CNL-17-100

Clinch River Nuclear Site
NRC Docket No. 52-047

Subject: Response to Request for Additional Information Number 5, Questions 02.05.01-03 and 02.05.01-05, Regarding Basis Geologic and Seismic Information in Support of Early Site Permit Application for Clinch River Nuclear Site

Enclosure 1
Response to NRC RAI Number 5, Question 02.05.01-03

Figure 2.5.1-83 (Sheet 1 of 2) Interpreted Seismic Reflection Profile from Tennessee Highway 95

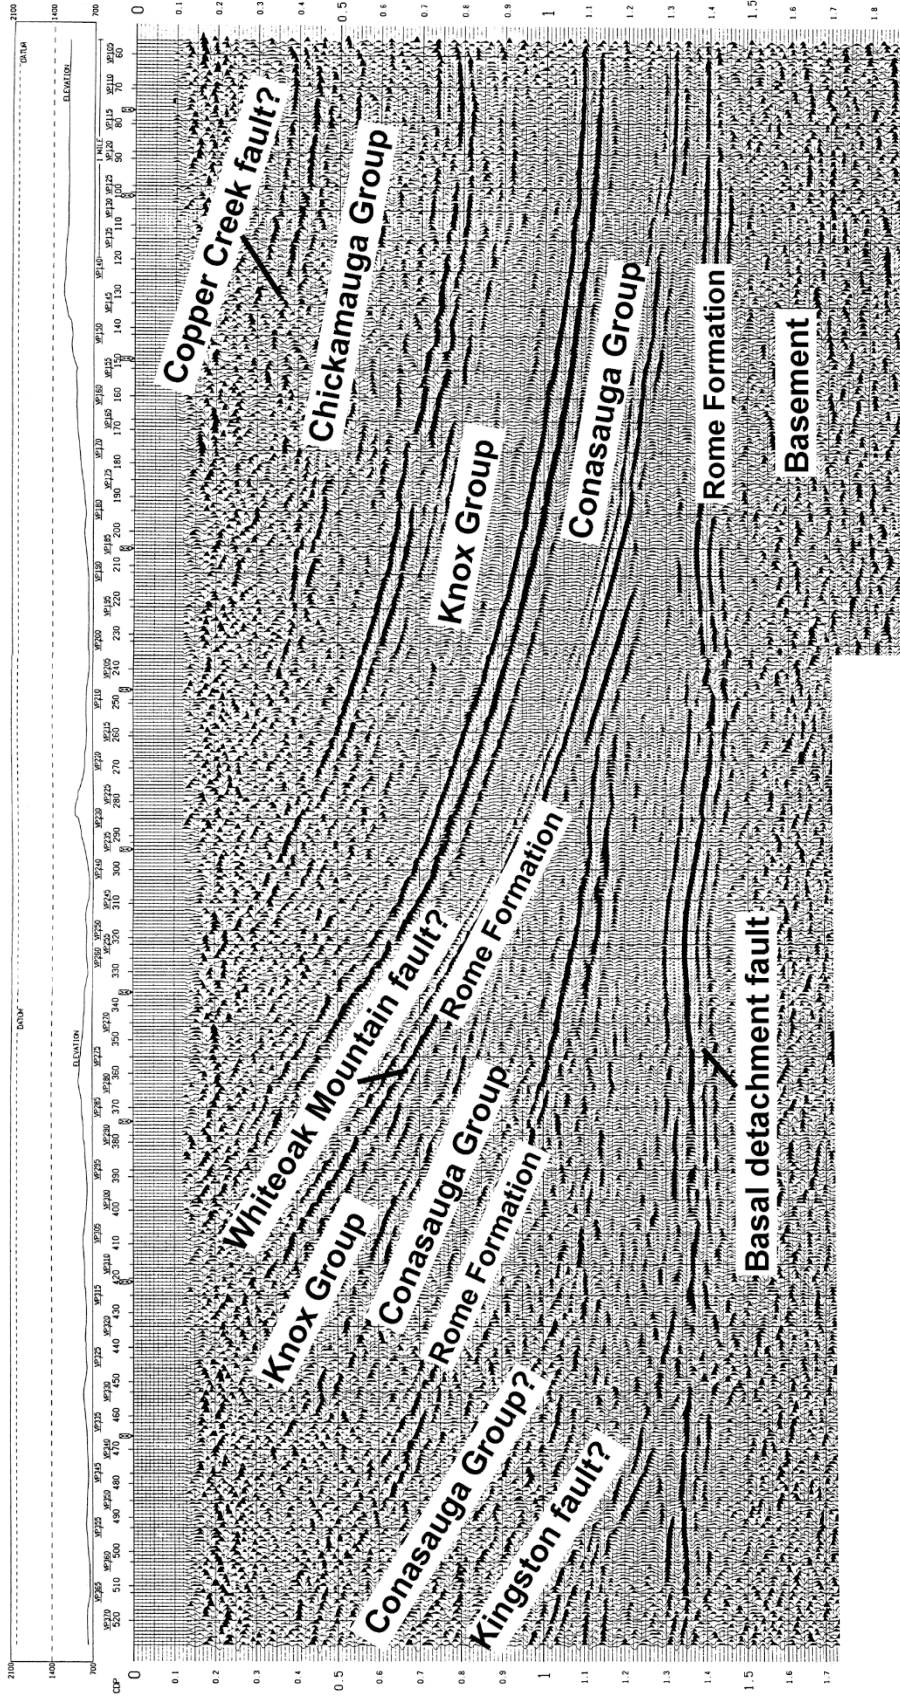
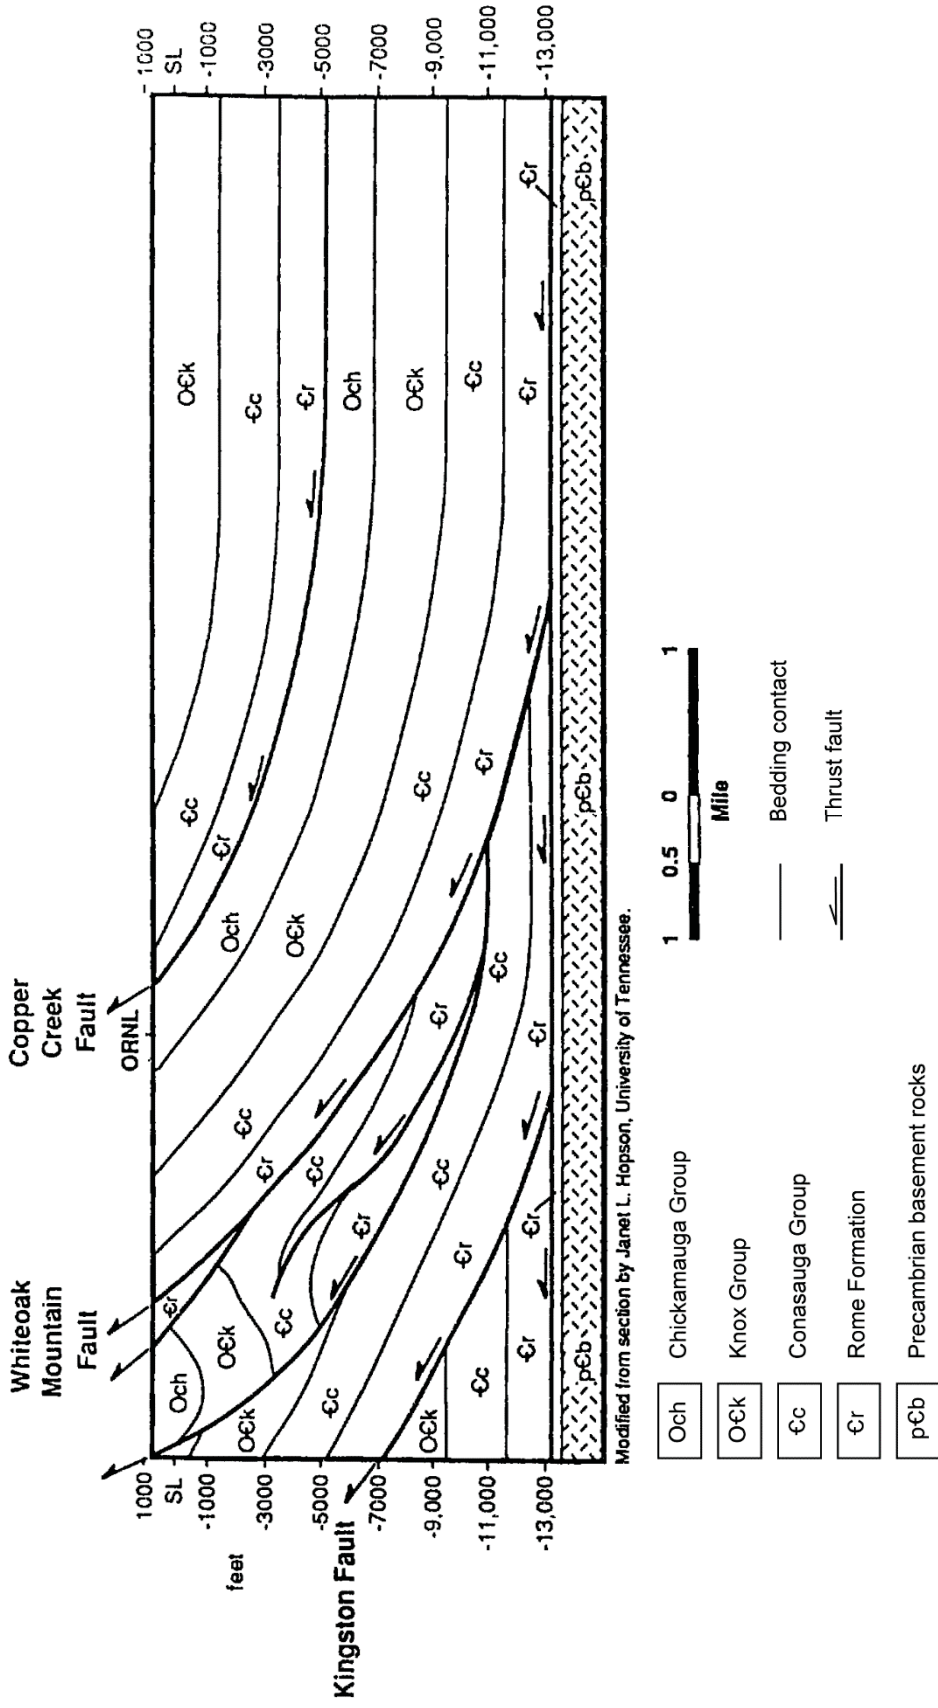
SSAR (Rev 0) Section 2.5.1.2.4.2.1 Geophysical Data, identifies two seismic reflection surveys, SRL-1 and SRL-2, conducted at the CRN Site. The SSAR (Rev 0) concludes that the many anomalies in the data could not be resolved by various processing routines and that none of the Alleghenian thrust faults that are located within the site location were identified in these data.

These features (tectonic faults and karst related voids) represent potentially adverse site conditions that affect compliance with 10 CFR 100.23 (c-d). However, based on the information provided in the SSAR (Rev 0), as well as the Doll et al. 2005 publication, it seems that neither karst voids nor known thrust faults at the site can be reliably identified by this geophysical method. Provide a technical basis for the applicability of the CRN seismic reflection investigations to resolve thrust structures (blind or otherwise) and voids and draw conclusions based on the seismic reflection. Including limits at which such features may be present but undetected at the site.

Thrust faults in foreland fold-thrust belts worldwide have been successfully imaged using seismic reflection geophysical techniques (e.g., References 1 through 5). Therefore, this technique was applied to identify possible similar subsurface structures at the CRN Site. The two seismic reflection surveys conducted at the CRN Site do not appear to image foreland fold-thrust belt faults, including previously mapped faults near the site (Whiteoak Mountain, Chestnut Ridge, and Copper Creek faults). The reasons that these faults were not imaged is not a function of the inability of seismic reflection to image foreland fold-thrust belt faults, but the location of the survey lines relative to the faults. For instance, the trace of the Whiteoak Mountain fault is approximately 10,000 ft northwest of the northwestern extent of both seismic reflection survey lines. Projection of this fault into the subsurface indicates it likely occurs at elevations of -7,000 ft with respect to mean sea level (MSL) to -8,000 ft MSL at the CRN Site, which is well below the depth imaged in seismic reflection profiles SRL-1 and SRL-2. The mapped trace of the Copper Creek fault crosses seismic reflection survey line SRL-1 at its southeastern end, which occurs where loss of data redundancy (fold) precludes reliable imaging or interpretation (Reference 6). The Chestnut Ridge fault of Lemiszki (Reference 7) is a relatively small-displacement thrust fault interpreted to juxtapose Chepultepec Dolomite against the Kingsport Formation (also dolomite) below the CRN Site (see cross section in SSAR Figure 2.5.1-64). The Chestnut Ridge fault trace occurs approximately 1,000 to 1,400 ft

Seismic reflection has been a reliable geophysical method for successfully imaging stratigraphy and faults in foreland fold-thrust belts, including the southern Appalachian Valley and Ridge (e.g., References 2.5.1-102 and 2.5.1-316). Hatcher et al. (Reference 2.5.1-102) present numerous balanced geologic cross sections throughout the eastern Tennessee Valley and Ridge Province that rely heavily on seismic reflection data, demonstrating the applicability of this method to delineate the subsurface structural geology in a foreland fold-thrust system. Additionally, Hatcher et al. (Reference 2.5.1-9) present a line drawing of their interpretation of a seismic reflection profile that was acquired along Tennessee Highway 95, approximately 2 mi. northeast of the CRN Site (Figure 2.5.1-83). Hatcher et al. (Reference 2.5.1-9) interpret the Whiteoak Mountain and Copper Creek faults on this profile, based on the mapped locations of the faults relative to the seismic reflection survey line and, for the Whiteoak Mountain fault, strong reflectors in the hanging wall that truncate reflectors in the interpreted footwall (Figure 2.5.1-83). Similar truncations are not visible along the Copper Creek fault in this seismic reflection profile, which is interpreted by Hatcher et al. (Reference 2.5.1-9) to represent parallel bedding above and below the fault (Figure 2.5.1-83, Sheet 2 of 2).

New SSAR Figure 2.5.1-83 is being added to SSAR Subsection 2.5.1:

Figure 2.5.1-84 Seismic Reflection Profile from Biscayne Bay, Florida, Showing Large Scale Sag Features Attributed to Hypogene Dissolution

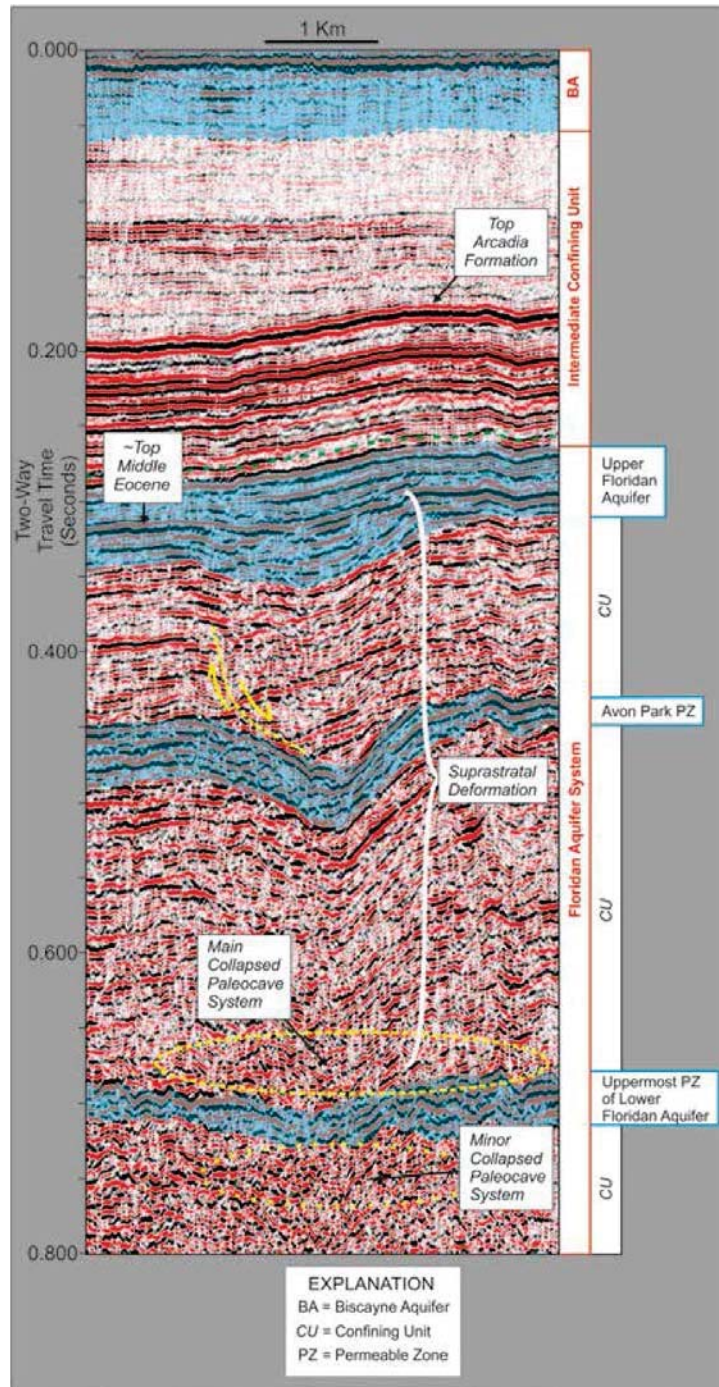
In addition, SSAR (Rev 0) Section 2.5.1.2.5.1 Karst Hazards, uses the same seismic reflection profiles to conclude that continuous, uninterrupted bedding at depth beneath the site suggests that large hypogenic karst collapse features are not present.

The seismic reflection data at the CRN Site was primarily collected to evaluate the bedrock structure and potential thrust faults in foreland fold-thrust belt as discussed above. The inherent uncertainty in seismic reflection data limits its capability to address the presence of karst. However, seismic reflection has been used to successfully evaluate karst at other sites. Discussions of hypogene dissolution examples in Biscayne Bay, Florida (References 8 through 10), and in the Shenandoah Valley, Virginia (Reference 11) are illustrated with figures from these references (see SSAR Figures 2.5.1-84 and 2.5.1-85). Geophysical studies in Biscayne Bay, Florida, demonstrate the applicability of seismic reflection to identify karst dissolution features. However, the karst features identified in Biscayne Bay are much larger than voids expected at the CRN Site.

The mixing of fresh water and salt water in coastal settings can also result in hypogene dissolution. Cunningham and Walker (Reference 2.5.1-41) and Cunningham et al. (Reference 2.5.1-318) describe multistoried vertical sag features evident in high resolution seismic reflection profiles from Biscayne Bay, Florida (Figure 2.5.1-84). They interpreted these stacked sag features, which range in diameter from 170 m (560 ft) to 3.2 km (10,500 ft), as evidence for coalesced, collapsed paleocave systems. Cunningham and Walker (Reference 2.5.1-41) proposed two hypogene mechanisms to explain these broad structural sags. They postulate upward flow driven by Kohout convection with dissolution by mixed fresh and saline groundwaters (Figure 2.5.1-85) and/or upward ascension of hydrogen-sulfide-charged groundwater derived from dissolution and reduction of calcium sulfates in deeper strata. Additionally, the faults associated with these collapse features may serve as pathways for upward ground water flow. This setting is highly susceptible to both epigenic and hypogenic karst processes due to the high porosity and permeability of Florida limestones and the frequent mixing of salt water and fresh water in groundwaters near the coast (Reference 2.5.1-295).

New Figure 2.5.1-84 is being added to SSAR Subsection 2.5.1:

Figure 2.5.1-29. (Sheet 2 of 2) Site Location Geologic Map Showing Borings

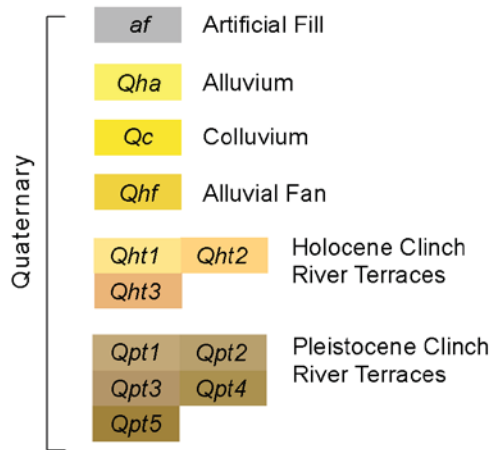
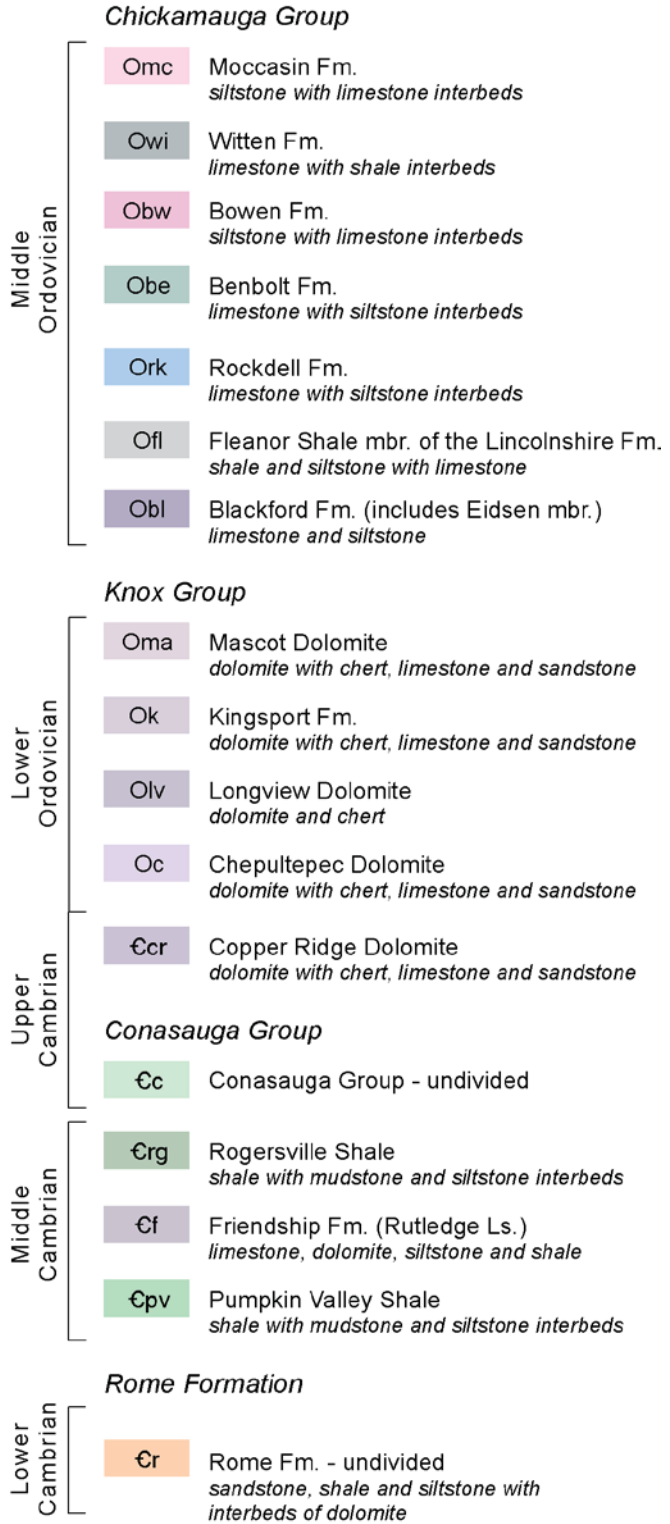
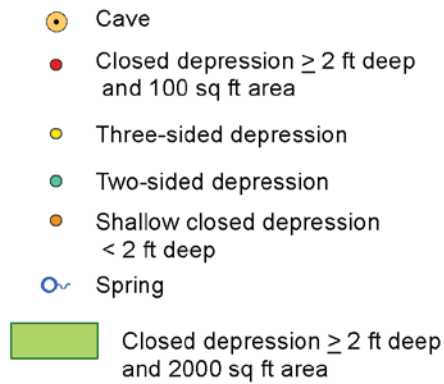
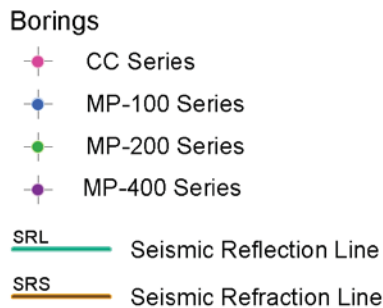
- a. SSAR (Rev 0) 2.5.3.2.3 Karst, indicates that seismic refraction surveys at the site were used to characterize carbonate dissolution features. Because no data were presented in the SSAR (Rev 0) regarding the characterization of the seismic refraction surveys, please discuss the specific evaluation of the seismic refraction data with respect to detecting carbonate dissolution features.*

Six seismic refraction lines were acquired at the CRN Site (Figure 2.5.1-29). The data are presented as seismic tomography models (Figure 2.5.1-86). Such models can be used to resolve complex velocity structure that cannot be imaged using layer-based modelling techniques (Reference 2.5.1-214). The primary objective of the seismic refraction surveys was to map the depth to bedrock in graded and filled areas within the central portion of the site. The data were also reviewed to identify anomalies that might indicate the presence of geologic structures such as blind faults or large karst dissolution features beneath the fill. The resolution of these data is not sufficient to identify small-scale features (less than 10 ft). The results of this review are presented in Subsection 2.5.1.2.5.1.2.
